Access Assessment Report

Richmond Centre of Excellence

Project: Richmond Centre of Excellence
Reference No: 113050C-Access-CoE-r2
Date: 28 April 2021
Client: NBRS Architecture
Client Contact: Stephanie Ferguson
Email: Stephanie.ferguson@nbrsarchitecture.com
BCA Logic Project: Alex Newberry
Direct: 0466 811 720
Email: anewberry@bcalogic.com.au

2.7. Design Items Requiring Attention

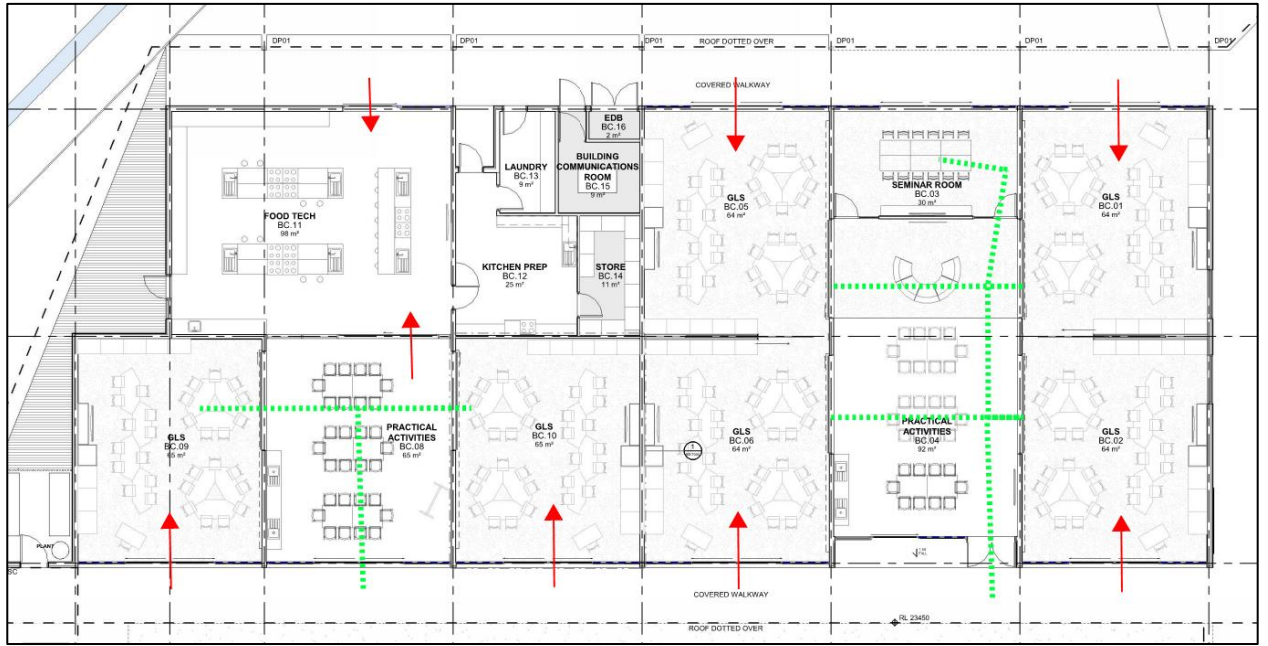
- (a) Accessible entry / doorways into each Block: Design team to consider and identify the accessible entry doors into each block and the accessible doors between learning spaces within each Block.

- Block C is an example below/
 - Is accessway provided into Practical Activities then via internal accessible sliding doors into each GLAS? Refer Green lines below.

- External sliding doors have challenges to being accessible: must have flush thresholds and have no more than 20N opening force. Weather protection at thresholds?

- Internal sliding doors can generally be hung from top rail for flush thresholds and more likely to achieve no more than 20N opening force for top hung doors with the correct sliding door hardware. Although, these internal doors are large, and consideration should be given how to achieve 20N opening force.

- Architect to nominate accessible entry doors and pathways within buildings.
